INDIANA DEPARTMENT OF TRANSPORTATION

APPROVED MINUTES

January 21, 2016 Standards Committee Meeting

<u>Item No. 02</u>	<u>(2016 SS)</u>	<u>Ms. Phillips</u>	<u>pg 10</u>
SECTION 604		SIDEWALKS, CURB RAMPS, STEPS, AND HANDRAILS	
905.05		Detectable Warning Elements	
Standard Drawings:			
604-SWCR-01		LOCATION PLAN FOR SIDEWALK CURB RAMP CURB RAMP DRAWING INDEX AND GENERAL NOTES	
604-SWCR-02		SIDEWALK CURB RAMPS GENERAL NOTES & DETAILS PERPENDICULAR CURB RAMP TYPICAL PLACEMENT	
604-SWCR-03		SIDEWALK CURB RAMP TYPE A PAIRED PERPENDICULAR CURB RAMPS TYPICAL PLACEMENT	
604-SWCR-04		SIDEWALK CURB RAMP TYPE B PERPENDICULAR CURB RAMP COMPONENT DETAILS

604-SWCR-01 LOCATION PLAN FOR SIDEWALK CURB RAMPS (WITH MARKUPS)

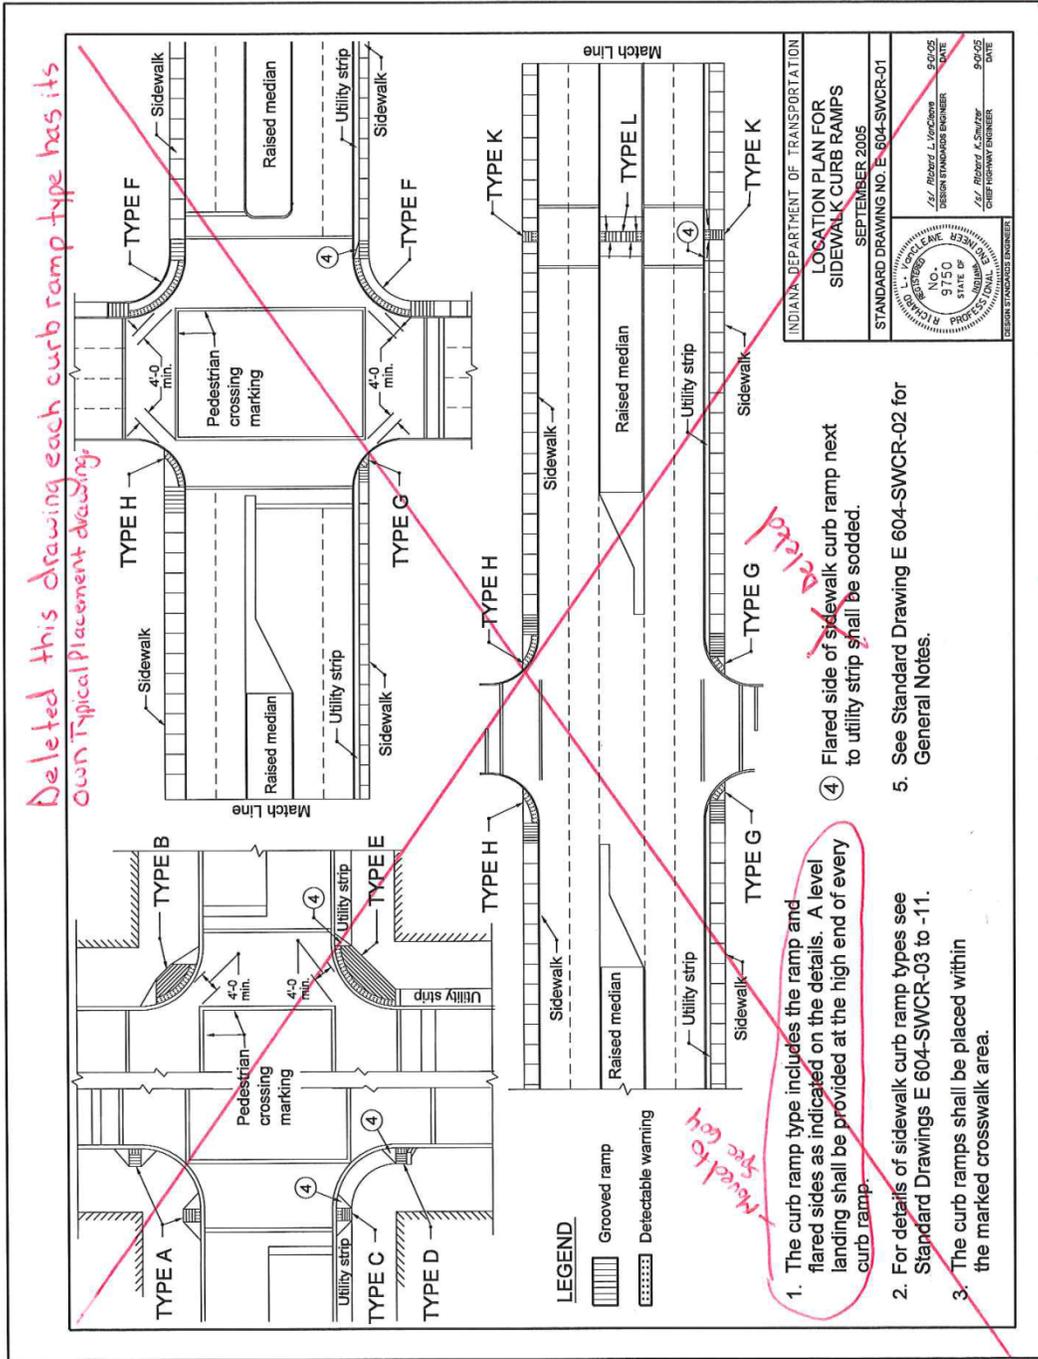
The entire SWCR series has been modified to reflect PROWAG. All new drawings have been created. We are proposing to eliminate letter curb types and replace with descriptive types i.e. perpendicular, parallel, etc. Proposed drawings now show design limits and typical placement only. All curb ramps shall be design needs.

6. Drainage inlets should be located uphill from curb ramps to prevent puddles at the path of travel.
7. See Standard Drawing E 604-SWCR-12 for improved access on narrow sidewalks. *Deleted*

8. Algebraic difference in grade between the base of curb ramp and the gutter shall be limited to less than 11%. If it is not practical, a 2'-0" wide level strip shall be provided. See detail sketch.

9. Minimum recommended width of curb ramp is 4'-0". *Similar Note kept on General Note drawing under width*

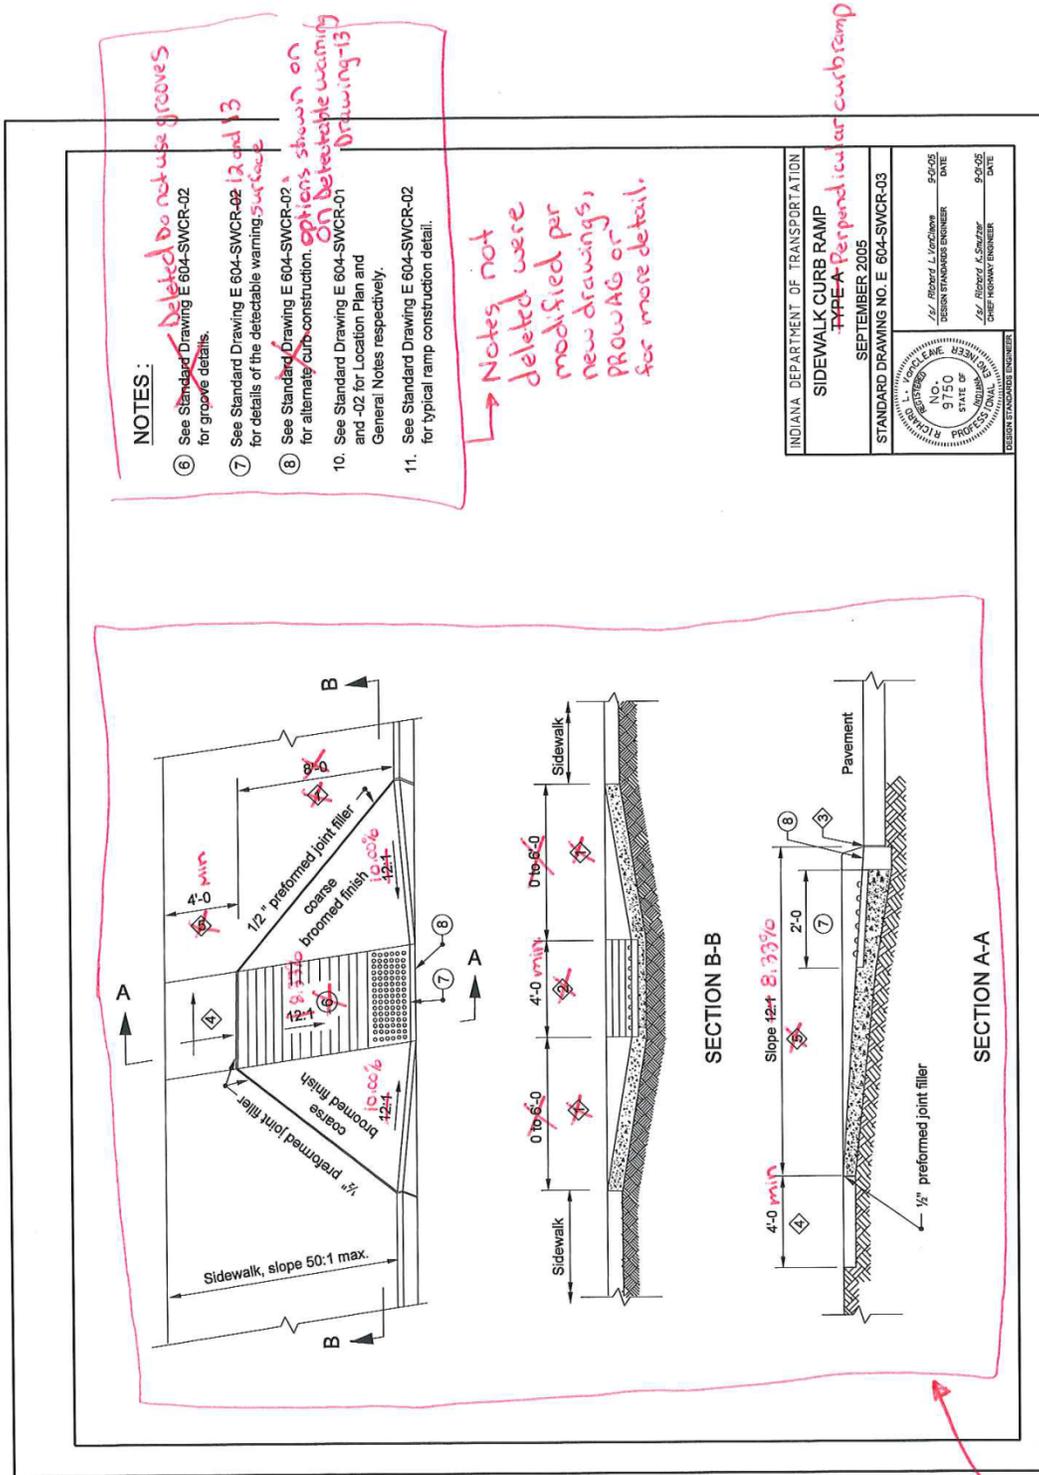
1. Landing area at top of turning space. *Note on General Notes Drawing; Running Slopes; Curb Slopes*

2. *Similar Note kept on General Note drawing under width*

3. *Added general picture of a curb ramp that shows all the curb ramp components and design elements and criteria for the components.*

Notes not deleted were modified per new drawings, PROWAG or for more detail.

Deleted do not use grooves
 Deleted do not use grooves
 Deleted do not use grooves
 Deleted do not use grooves

INDIANA DEPARTMENT OF TRANSPORTATION
 SIDEWALK CURB RAMP
 TYPE A Perpendicular curb ramp
 SEPTEMBER 2005
 STANDARD DRAWING NO. E 604-SWCR-03

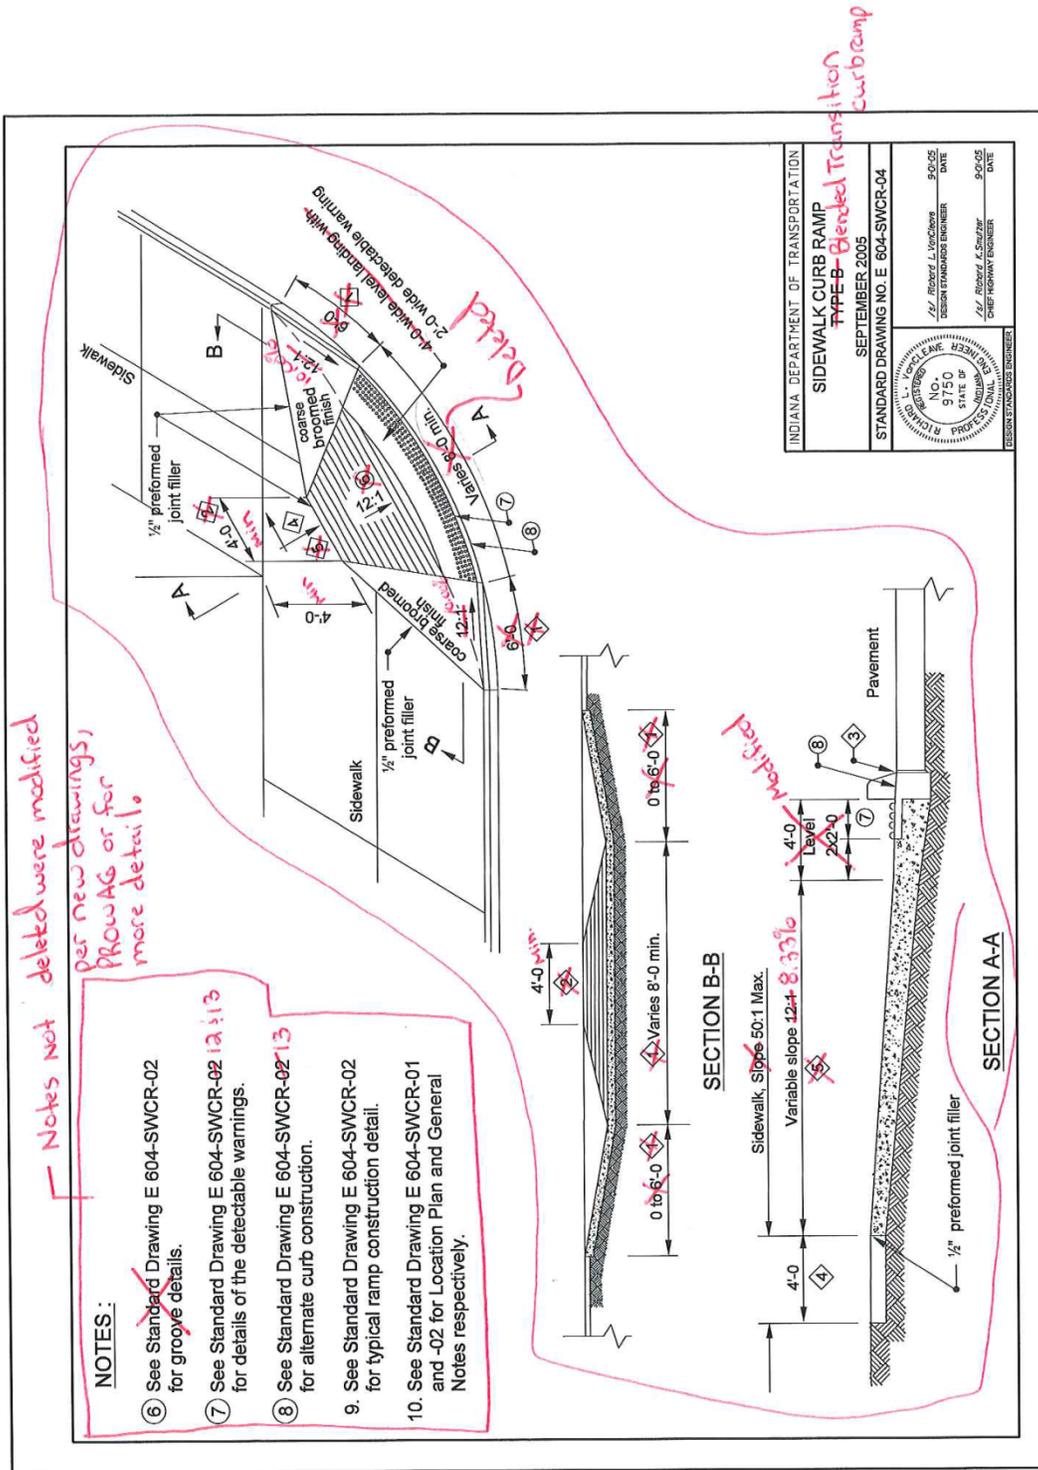
All curb ramps shall be designed in the construction plans. Only slopes and min. dimensions are shown. Perpendicular curb ramps have 3 drawings (02, 03, 04) showing typical placement and component details.

Notes not deleted were modified per new drawings, PROWAGs or for more detail.

604-SWCR-05 SIDEWALK CURB RAMPS TYPE C (WITH MARKUPS)

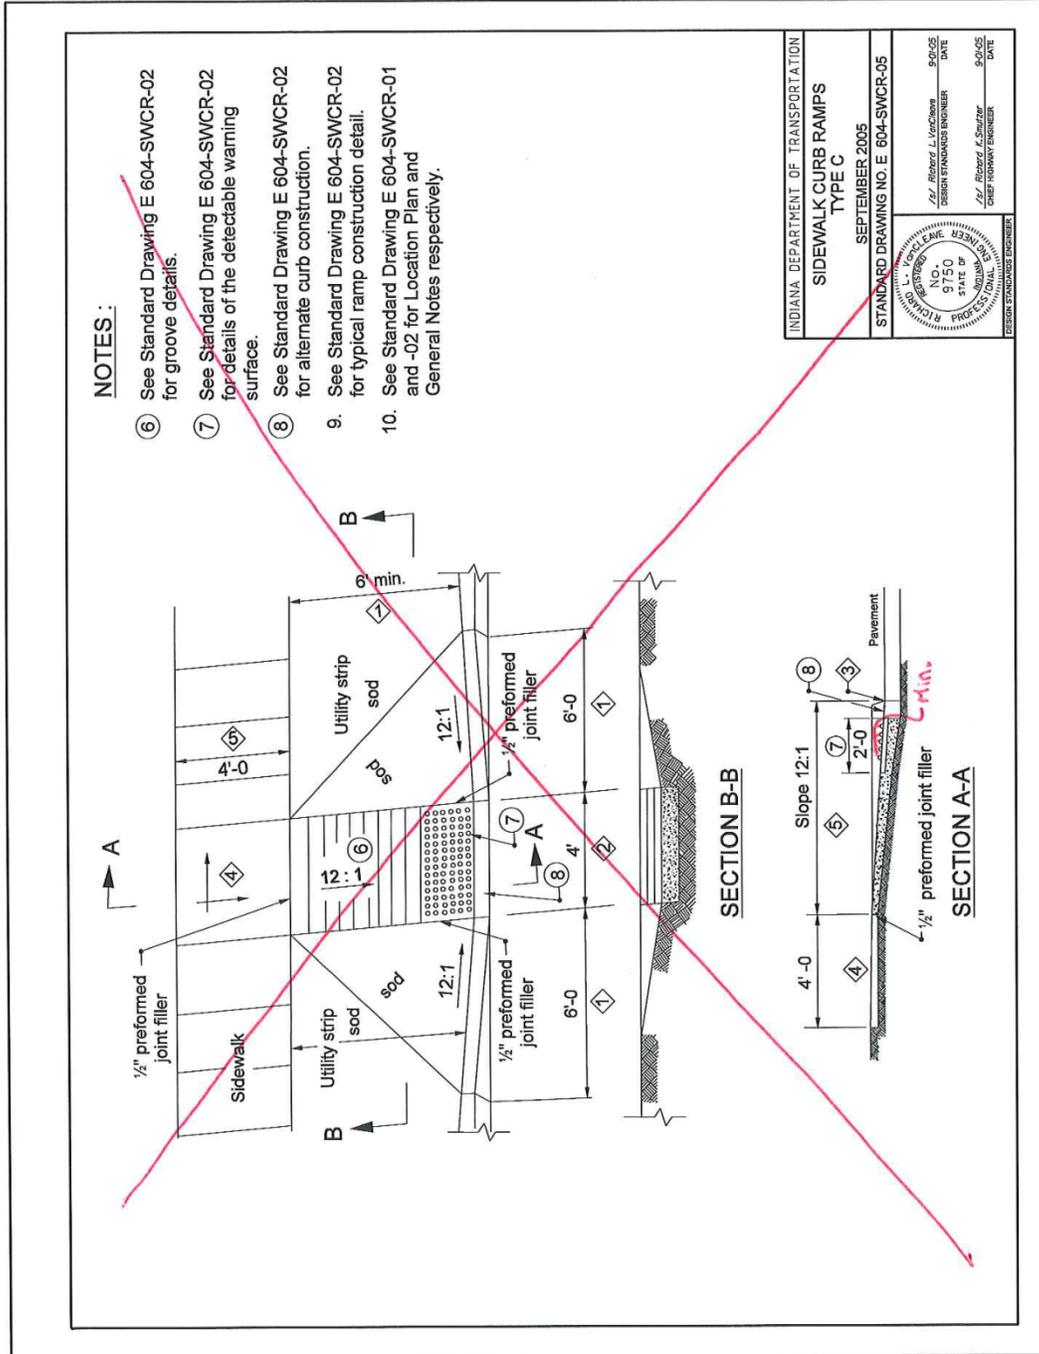
Covered under Perpendicular Curb ramp drawings (02,03,04).

604-SWCR-06 SIDEWALK RAMP CURB TYPE D (WITH MARKUPS)

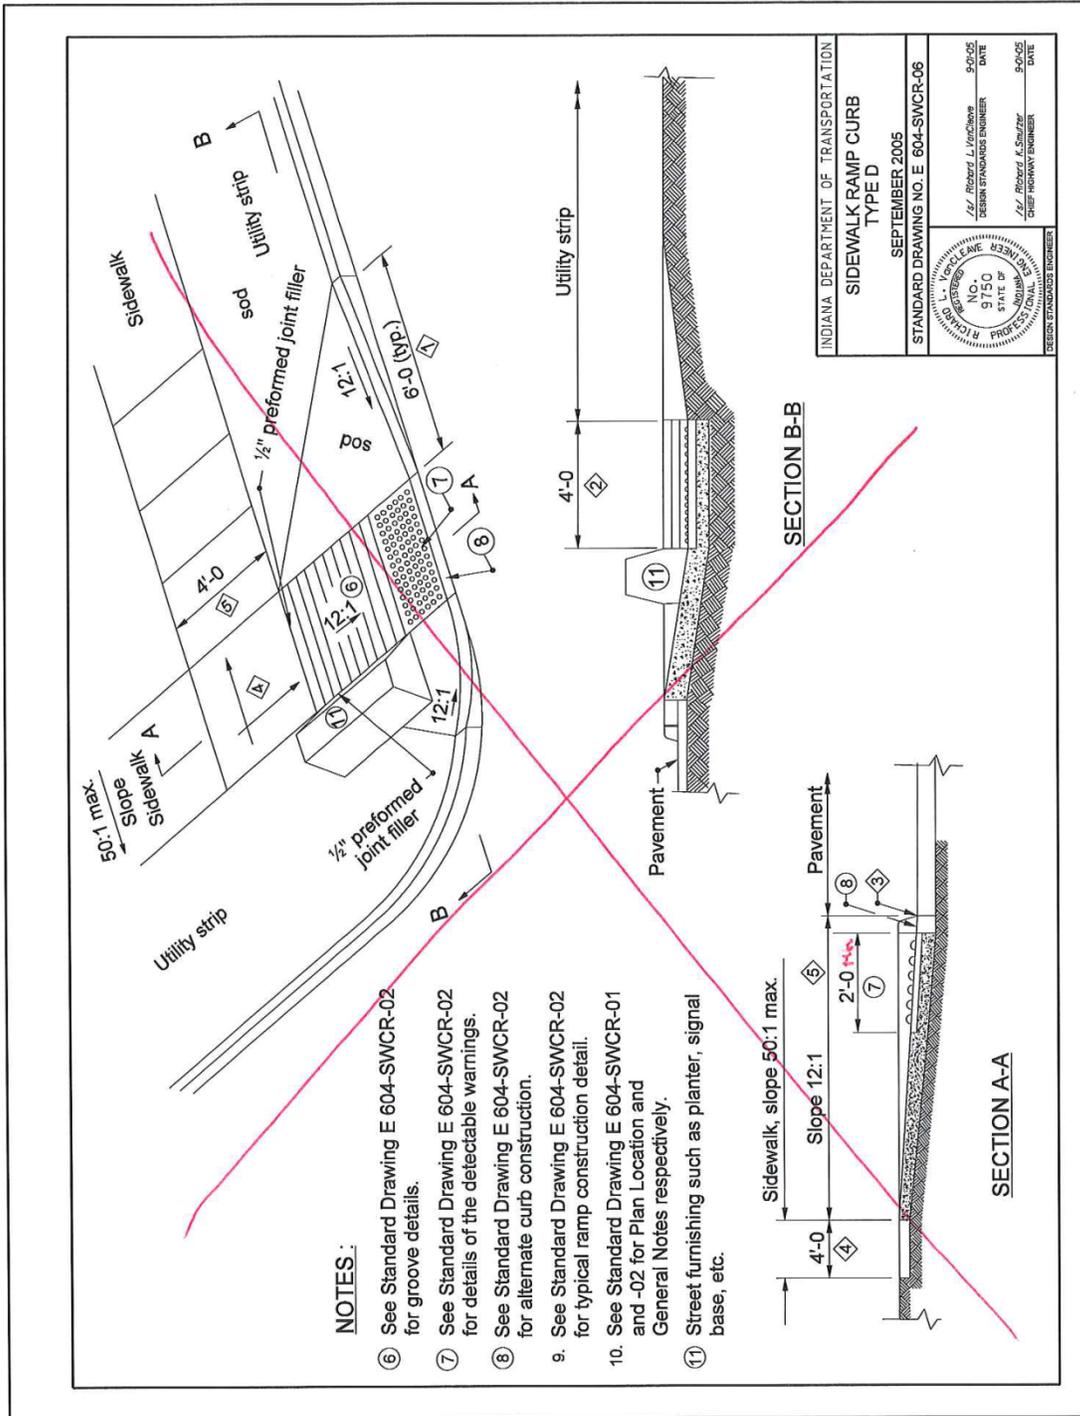
covered by perpendicular curb ramp drawings (02, 03, 04)

604-SWCR-07 SIDEWALK CURB RAMPS TYPE E (WITH MARKUPS)

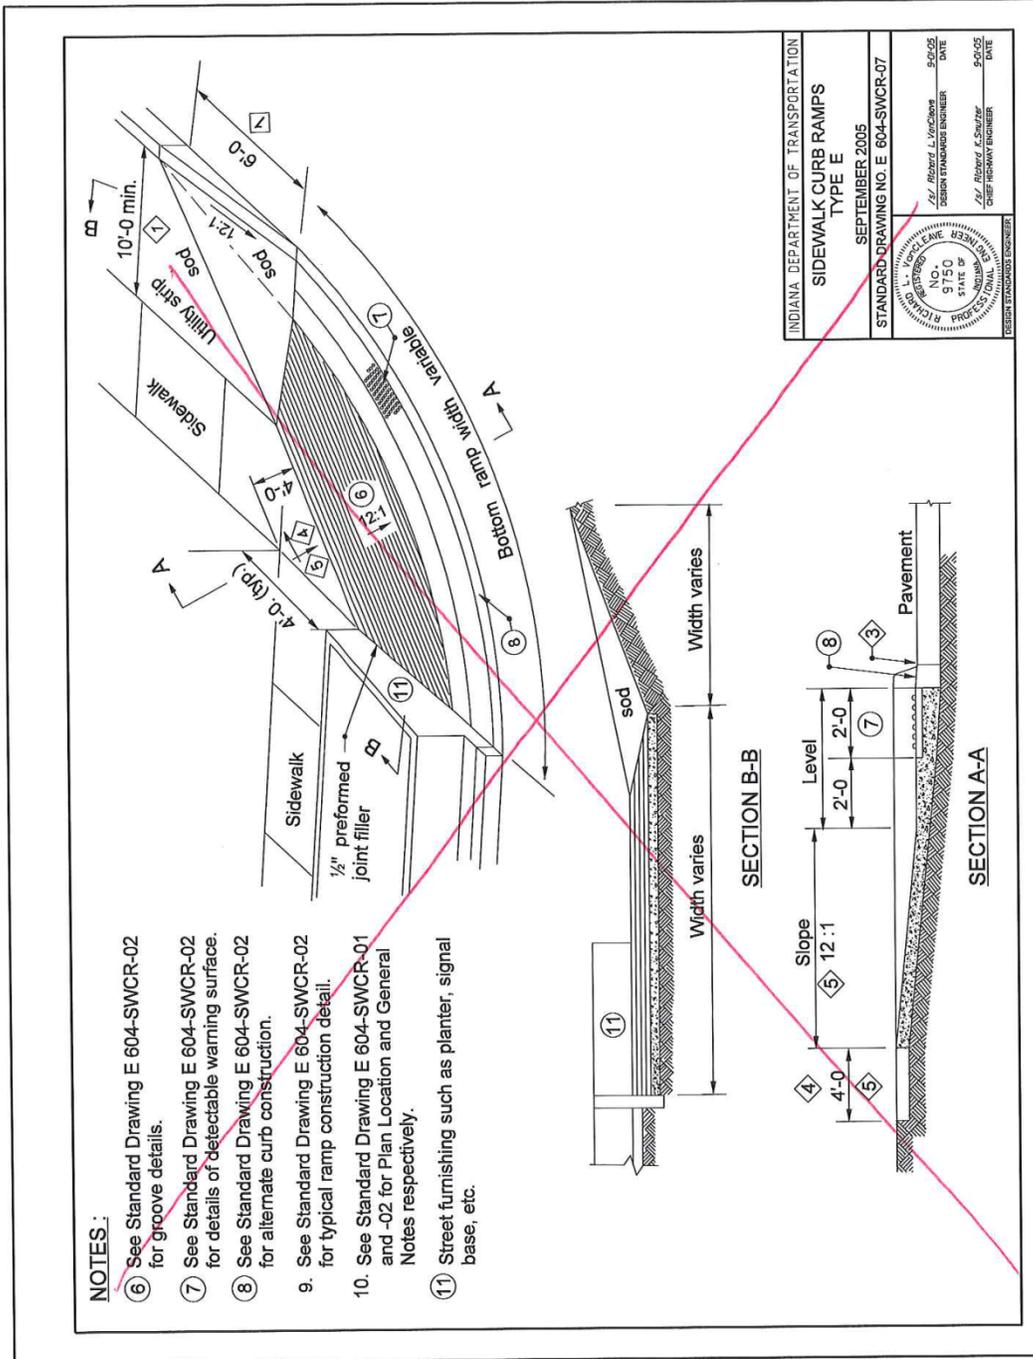
Covered by Blended transition curb ramp drawings (09 & 10)

604-SWCR-09 SIDEWALK CURB'S RAMP'S TYPE G AND TYPE H (WITH MARKUPS)

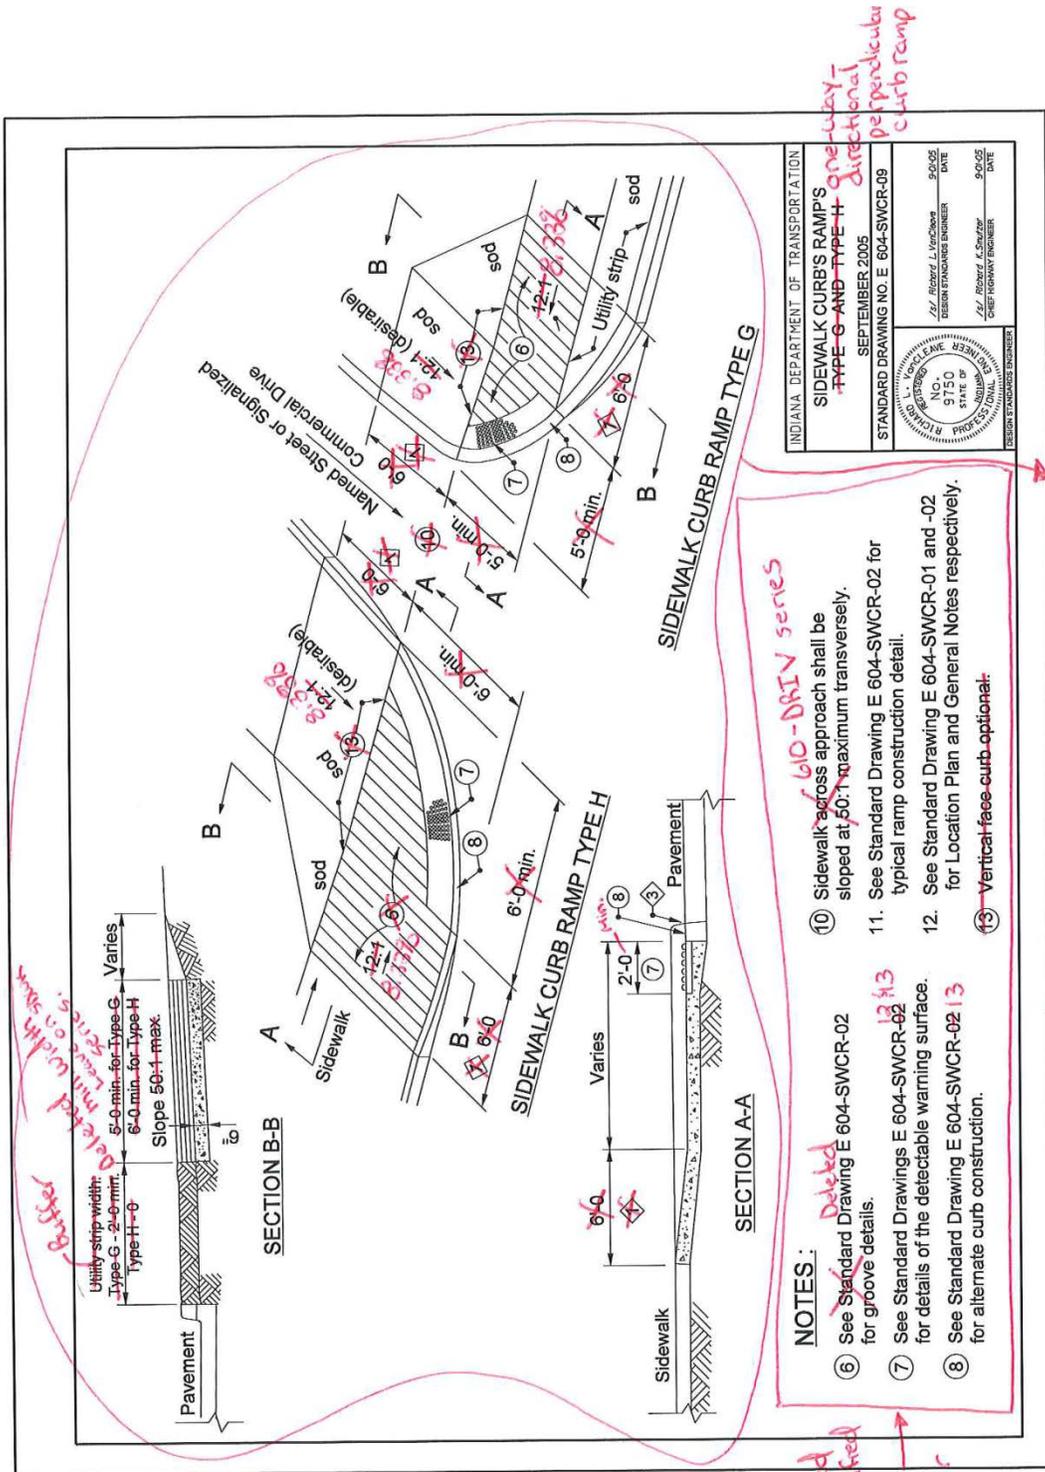
Notes
 Not deleted
 were modified
 per new
 drawing
 showing
 for more
 detail

Deleted with 604-SWCR-09 series.
 Deleted with 604-SWCR-09 series.
 Deleted with 604-SWCR-09 series.
